# RETREAT AT TIMBERRIDGE FILING NO. 3

## COUNTY OF EL PASO, STATE OF COLORADO

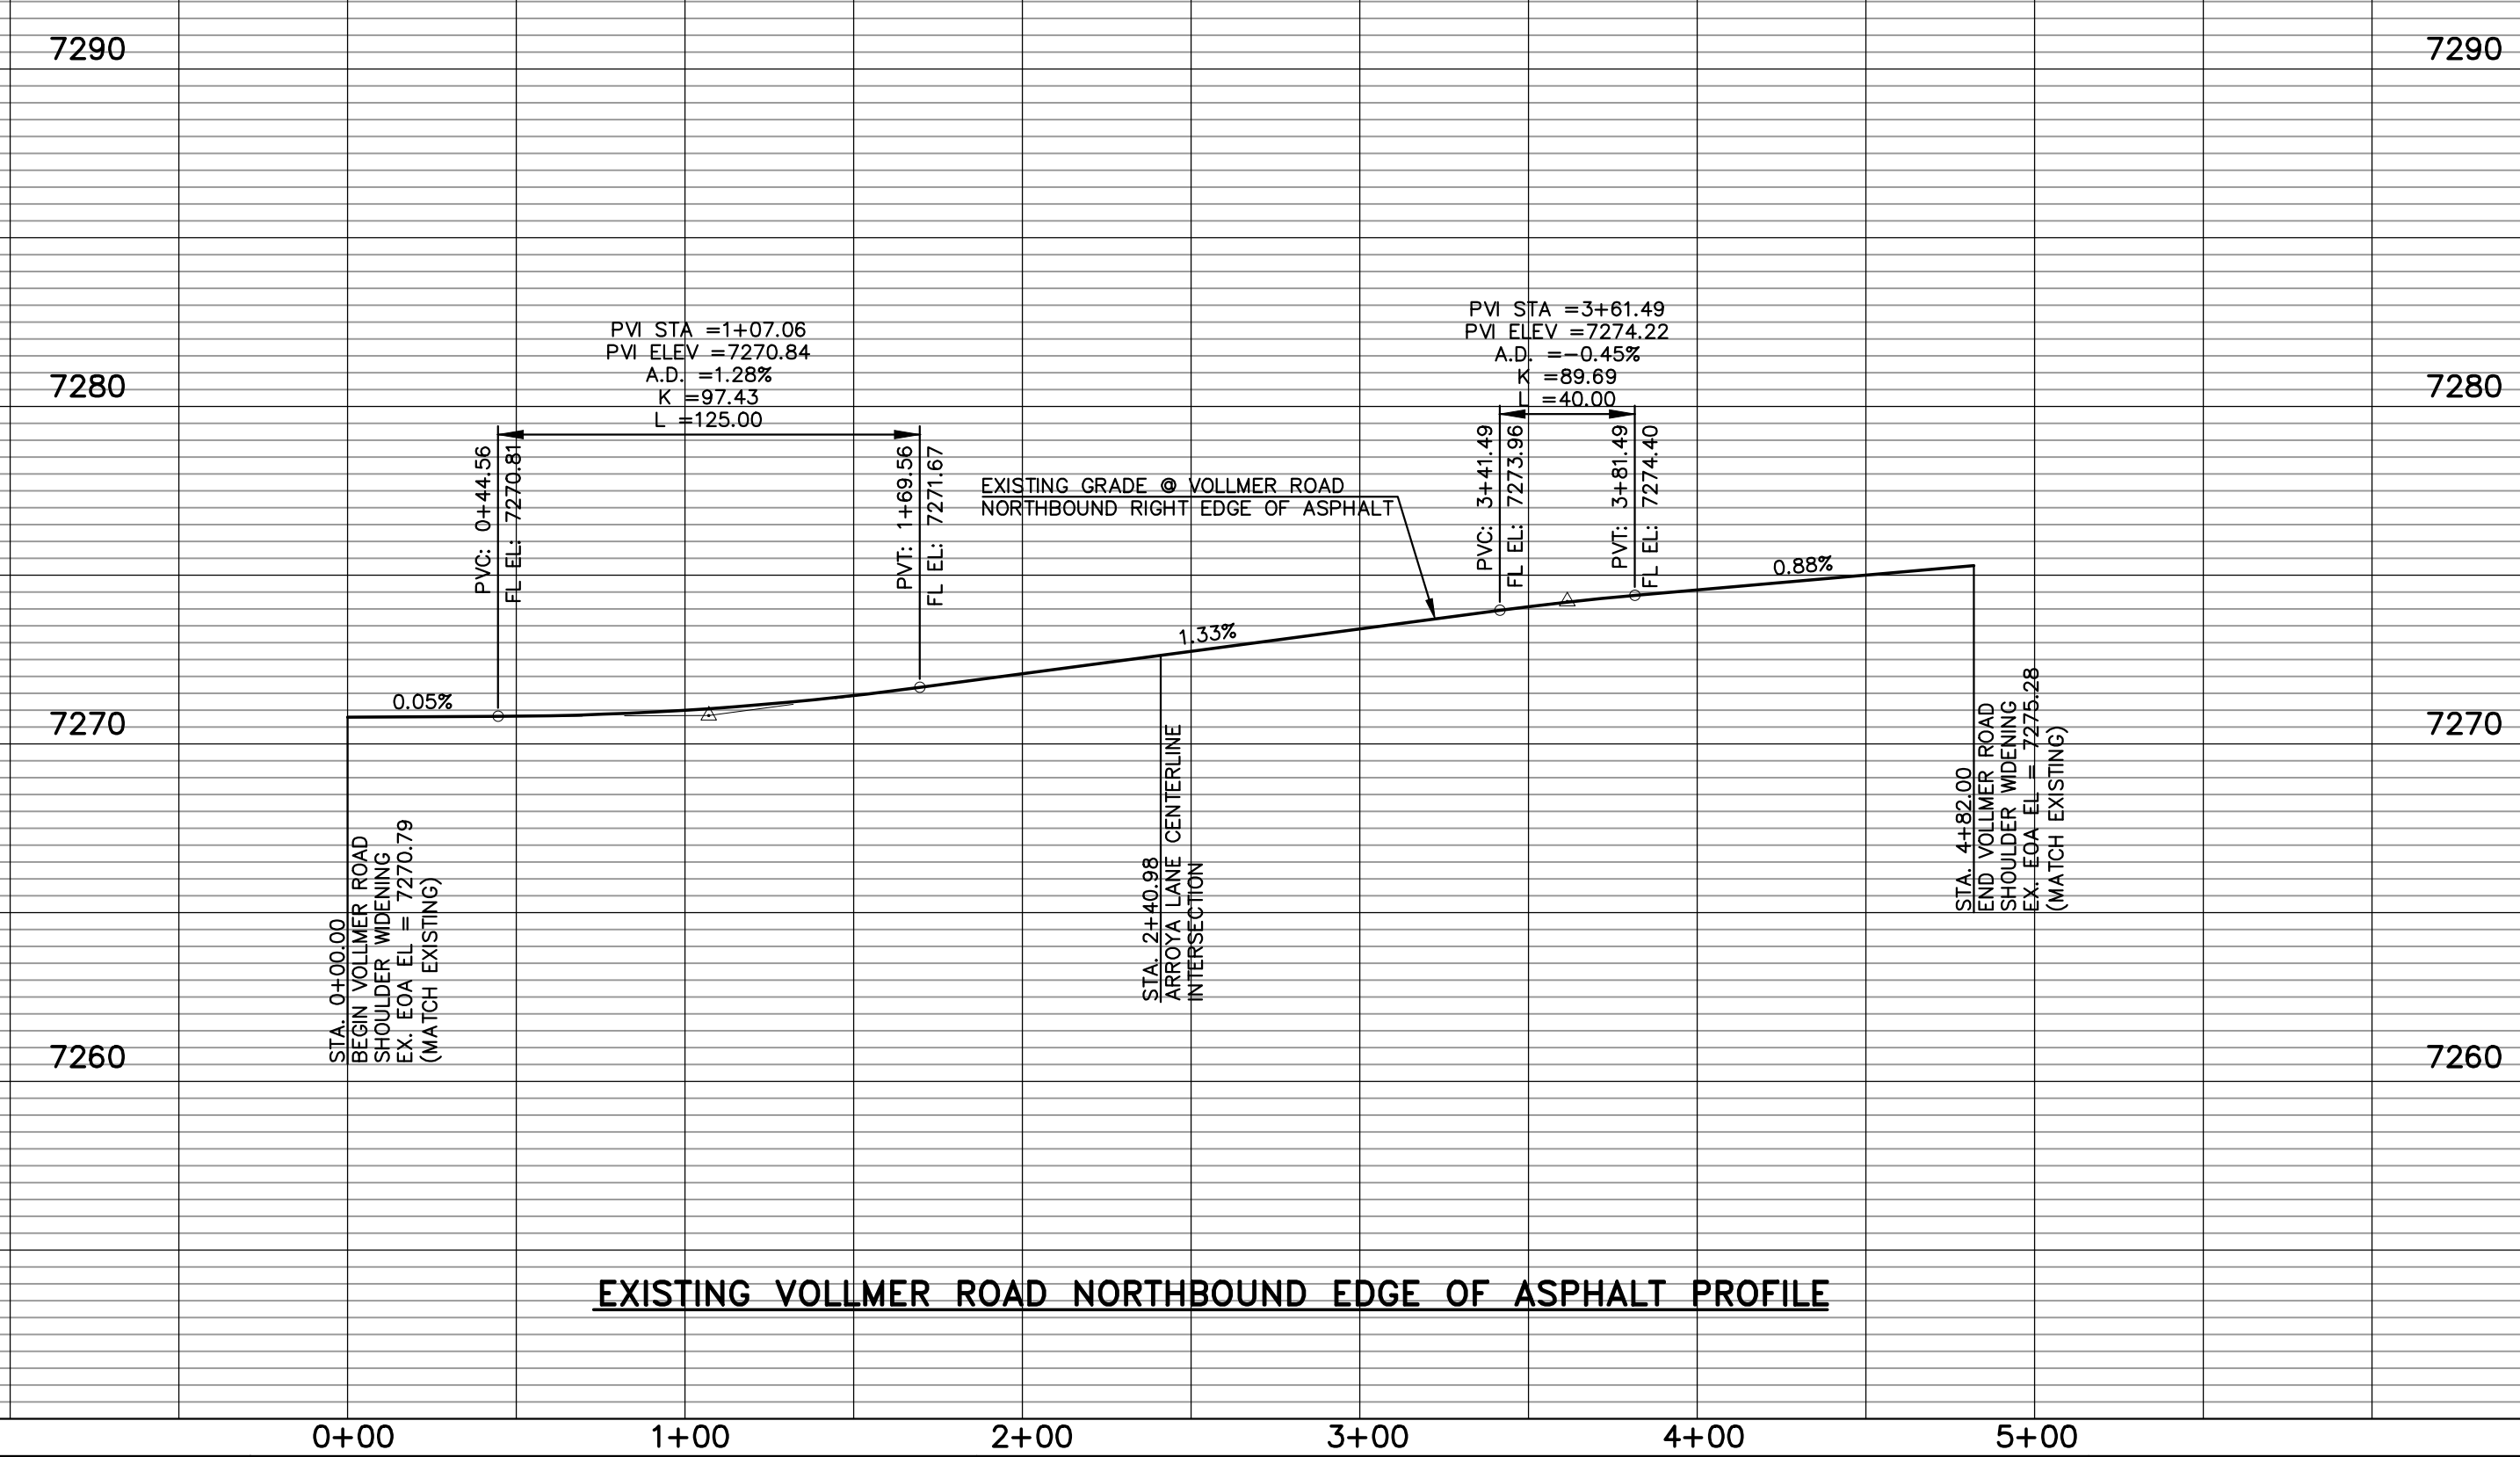
<p>48 HOURS BEFORE YOU DIG, CALL UTILITY LOCATORS <b>811</b> UTILITY NOTIFICATION CENTER OF COLORADO IT'S THE LAW</p> <p>THE LOCATIONS OF EXISTING UNDERGROUND UTILITIES ARE SHOWN IN AN APPROXIMATE WAY ONLY. THE CONTRACTOR SHALL DETERMINE THE EXACT LOCATION OF ALL EXISTING UTILITIES BEFORE COMMENCING WORK. THE CONTRACTOR SHALL BE FULLY RESPONSIBLE FOR ANY AND ALL DAMAGES WHICH MIGHT BE CAUSED BY HIS FAILURE TO EXACTLY LOCATE AND PRESERVE ANY AND ALL UNDERGROUND UTILITIES.</p>	<p>NO. REVISION</p> <table border="1"> <tr> <td>1</td> <td>REVISED PER EPC COMMENTS</td> <td>3-07-23</td> </tr> <tr> <td>2</td> <td>REVISED PER EPC COMMENTS</td> <td>10/31/23</td> </tr> </table>	1	REVISED PER EPC COMMENTS	3-07-23	2	REVISED PER EPC COMMENTS	10/31/23	<p>REVIEW:</p> <p>PREPARED UNDER MY DIRECT SUPERVISION FOR AND ON BEHALF OF CLASSIC CONSULTING AND SURVEYORS, LLC</p> <p>MARC A. WHORTON, REGISTERED PROFESSIONAL ENGINEER #37155</p>	<p>DATE: 2/2/2024</p>	<p>RETRAIT AT TIMBERRIDGE FILING NO. 3 CONSTRUCTION PLANS STREET IMPROVEMENT PLANS VOLLMER ROAD EAST SHOULDER WIDENING</p>
	1	REVISED PER EPC COMMENTS	3-07-23							
2	REVISED PER EPC COMMENTS	10/31/23								
<p>DESIGNED BY: PRA</p> <p>DRAWN BY: PRA</p> <p>CHECKED BY:</p>	<p>SCALE: (H) 1" = 50'</p> <p>(V) 1" = 5'</p>	<p>DATE: 11-22-2022</p> <p>SHEET: 11 OF 27</p> <p>JOB NO.: 1185.30</p>	<p>619 N. Cascade Avenue, Suite 200 Colorado Springs, Colorado 80903</p> <p>(719) 785-0790 (719) 785-0799 (Fax)</p>

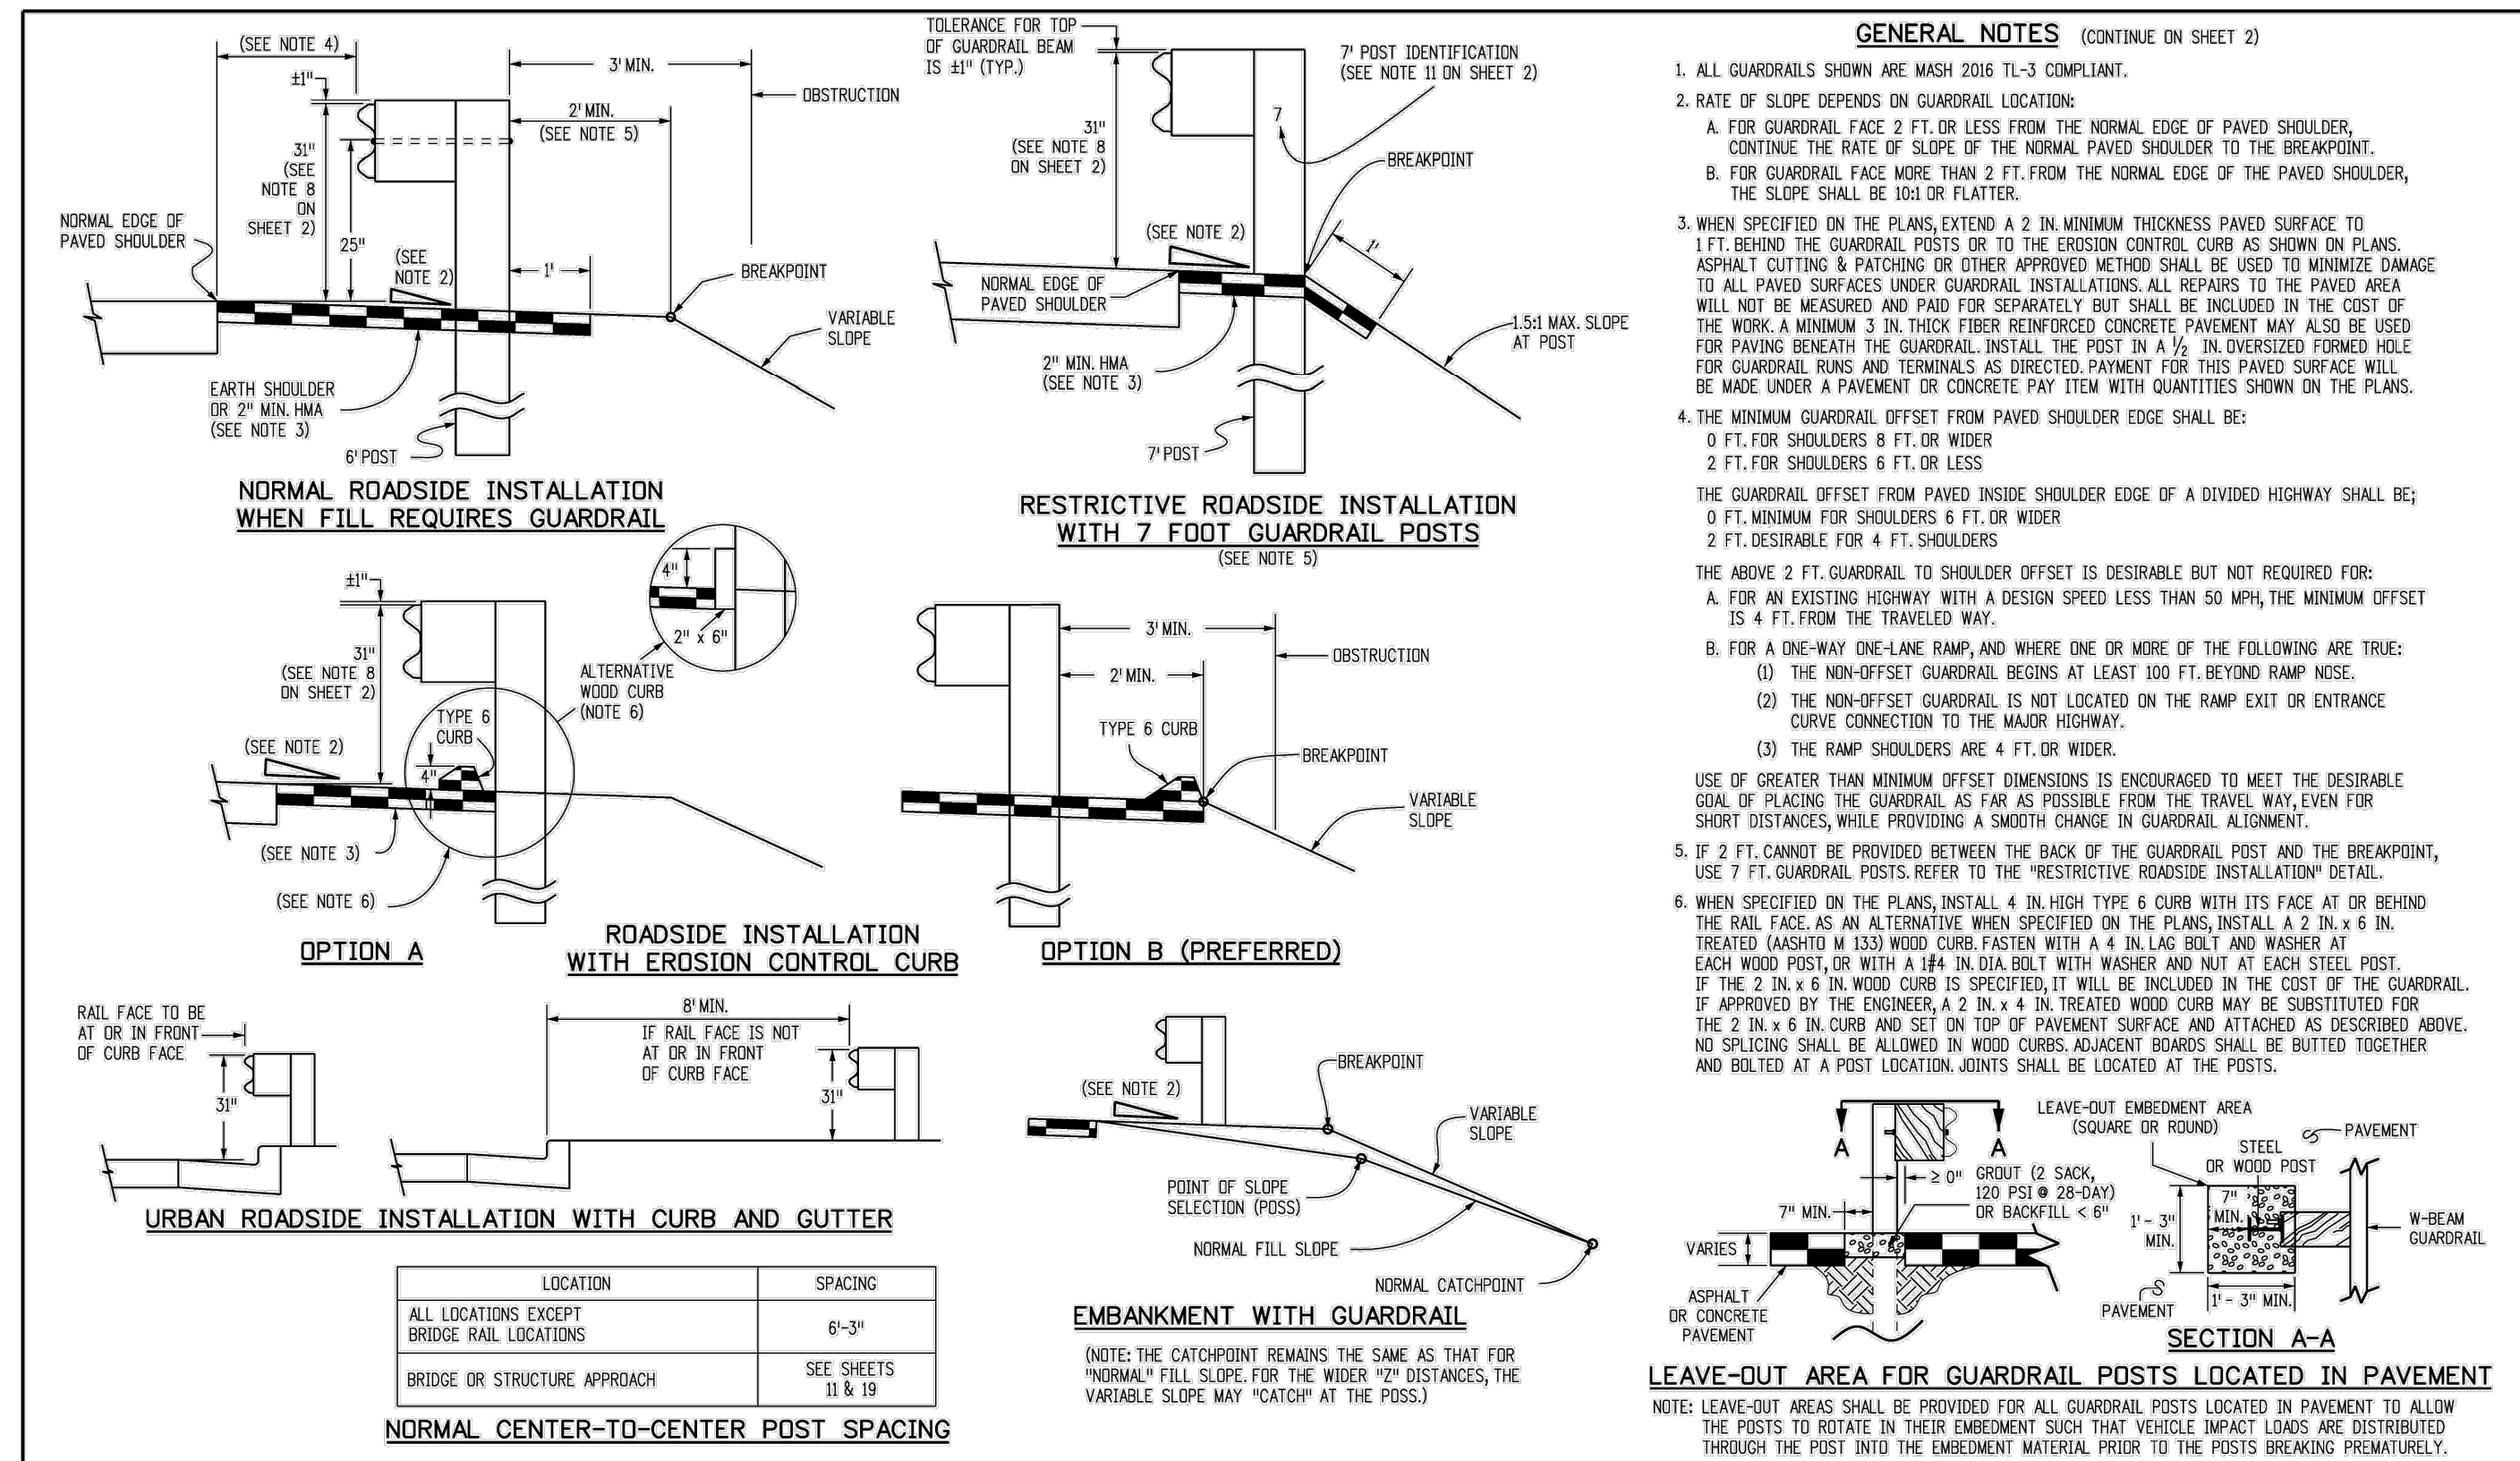
<b>Computer File Information</b>		<b>Sheet Revisions</b>		<b>Colorado Department of Transportation</b>		<b>MIDWEST GUARDRAIL SYSTEM (MGS) TYPE 3 W-BEAM 31 INCHES</b>		<b>STANDARD PLAN NO. M-606-1</b>	
Creation Date: 07/31/19	Designer Initials: JBR	Date: 03/05/20	Comments: Revised per Note 1 to show MASH compliant	2829 West Howard Place	CDOT HQ, 3rd Floor	Denver, CO 80204	Phone: 303-757-9021 FAX: 303-757-9868	Standard Sheet No. 1 of 19	Project Sheet Number:
Last Modification Date: 03/05/20	Detailer Initials: LTA			<b>Project Development Branch</b>		<b>JBK</b>		Issued by the Project Development Branch July 31, 2019	
CAD Ver: MicroStation V8	Scale: Not to Scale	Units: English						Project Sheet Number:
